Project No. 18-114
ADDENDUM NO. 1
March 14, 2019

EAST BATON ROUGE PARISH COUNCIL ON AGING
DRAINAGE AND PAVING REPAIRS
THE DUMAS HOUSE
1313 N SHERWOOD FOREST BLVD
BATON ROUGE, LA 70815

ADDENDUM NO. 1

EXHIBIT A

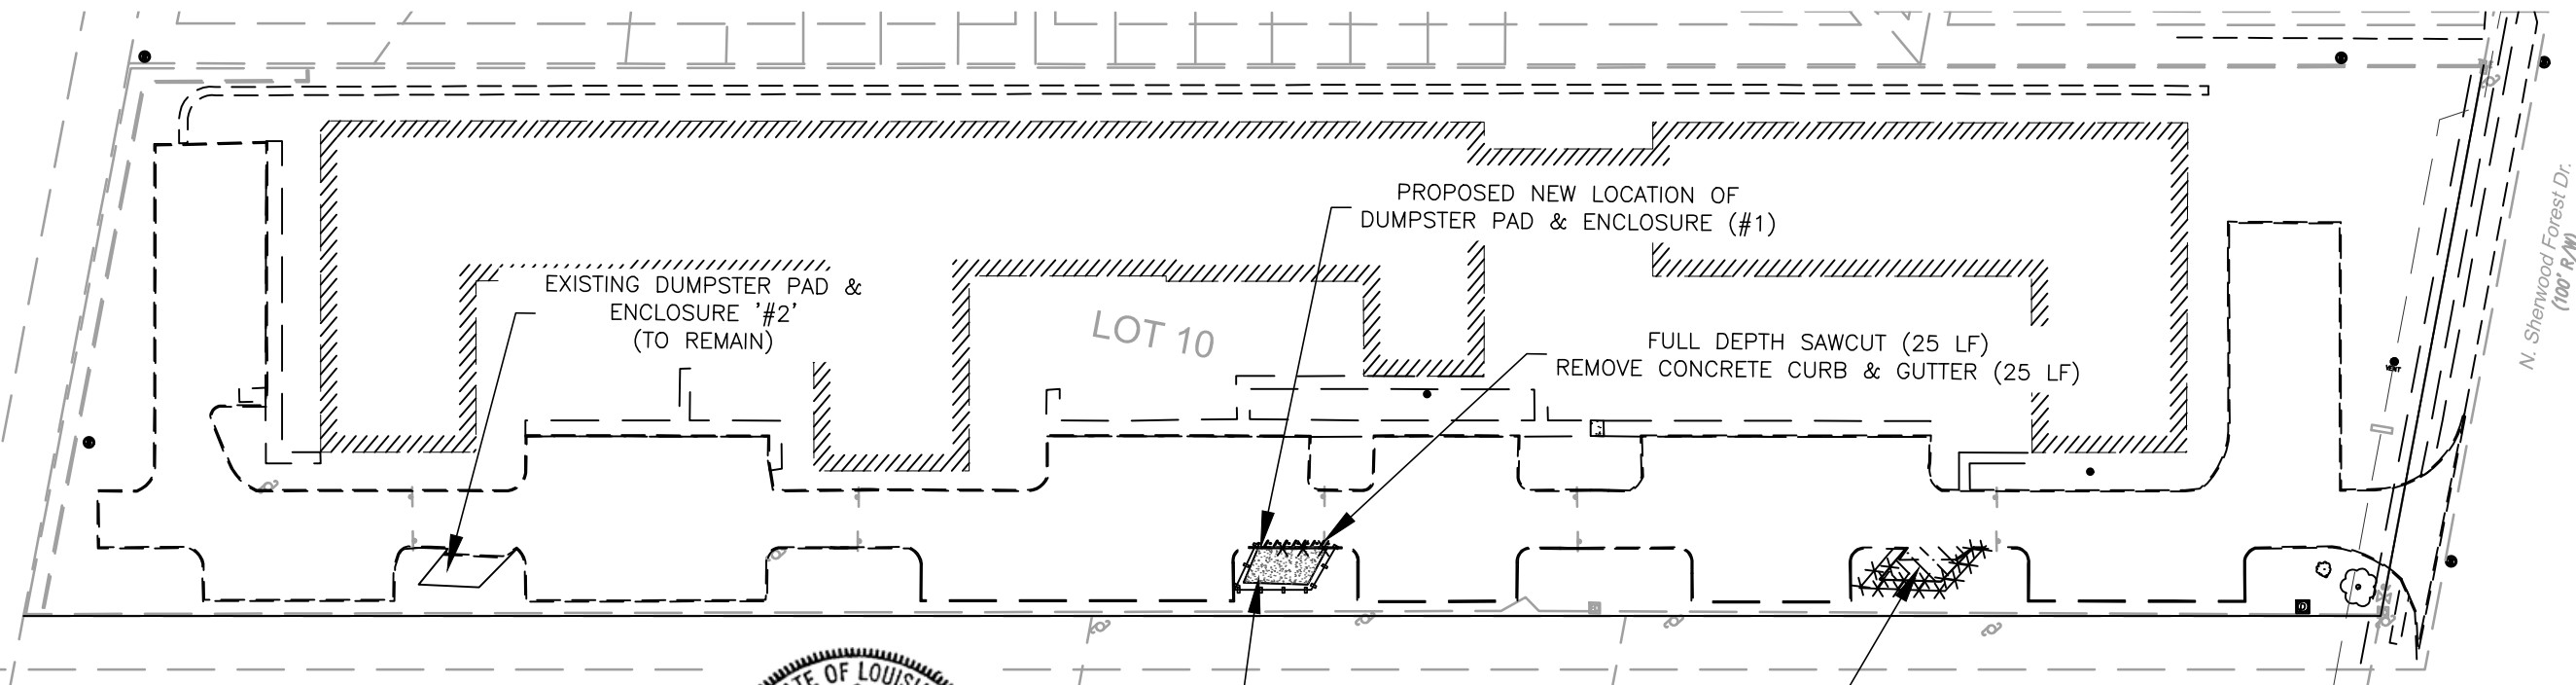
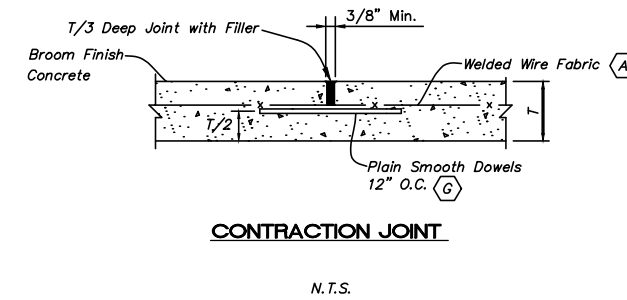
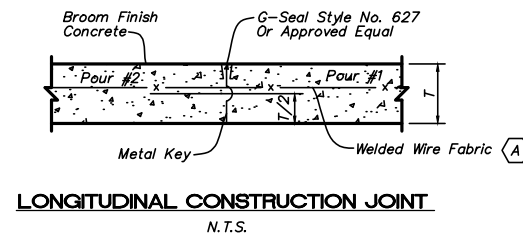
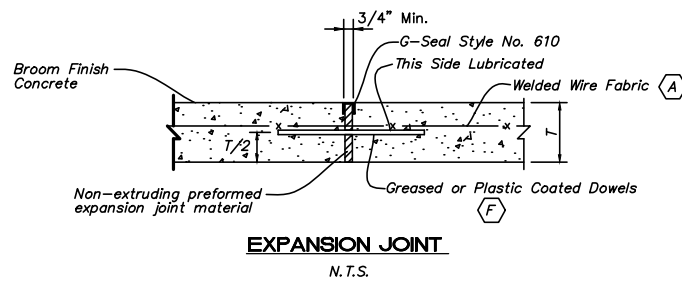
2. Jersey Barrier / Water Barriers are not required for Alternate #3.
3. A full-time superintendent will be required as per the project manual.
4. Two existing Dumpsters and Dumpster Pads are located on site. Refer to Attached EXHIBIT A – DUMPSTER RELOCATION PLAN. Existing Dumpster Pad & Enclosure #1 to be removed and relocated to new location as noted. G.C. shall provide labor and materials for new concrete pad and curb as detailed.

- PROP. 8" CONCRETE PAD (450 SF)
- PROP. CURB & GUTTER (61 LF)
- PROP. 8'H WOOD DUMPSTER ENCLOSURE (80 LF)
- EXISTING DUMPSTER PAD & ENCLOSURE (#1)
- REMOVE CONCRETE PAD (FULL DEPTH) (450 SF)
- REMOVE CONCRETE CURB & GUTTER (61 LF)
- DEMO WOOD ENCLOSURE (80 LF)
